MOTION PRO, INC.
3171 Swetzer Road
Loomis, CA 95650
Tel 650.594.9600 Fax 650.594.9610
www.motionpro.com

WARNING: Rev2 Throttle Housing and Tube Revision – Please read before you install!

The critical dimension is the width of the throttle stop on the throttle tube:

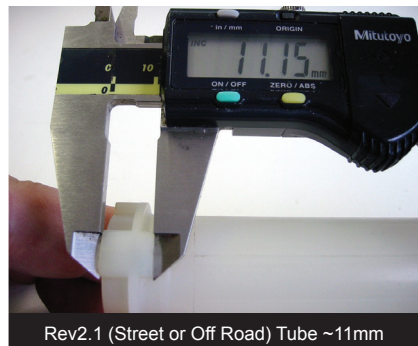
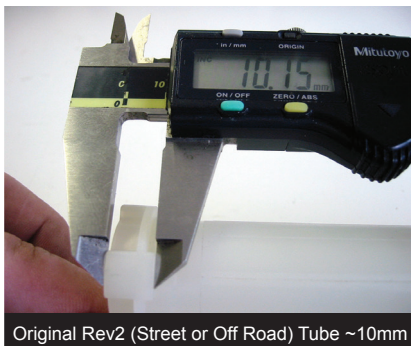
A running change was made to the Rev2 Housing and both the Off Road and Street Tubes to increase the size of the throttle stop for greater durability. **The parts are not interchangeable and incorrect assembly could result in great bodily injury or death.** Each generation has its own set of part numbers:

WARNING: Do not use a Rev 2.1 throttle tube in an older housing. Doing so could cause the throttle to bind and could result in great bodily injury or death. An original Rev2 tube will fit and function in a revised Rev2.1 housing. If you have any questions or concerns about the correct fitment on your throttle assembly, contact Motion Pro. If you have purchased a new Rev2.1 throttle tube and have the old version Rev2 housing, please contact Motion Pro at (650) 594-9600 for a free replacement updated housing.
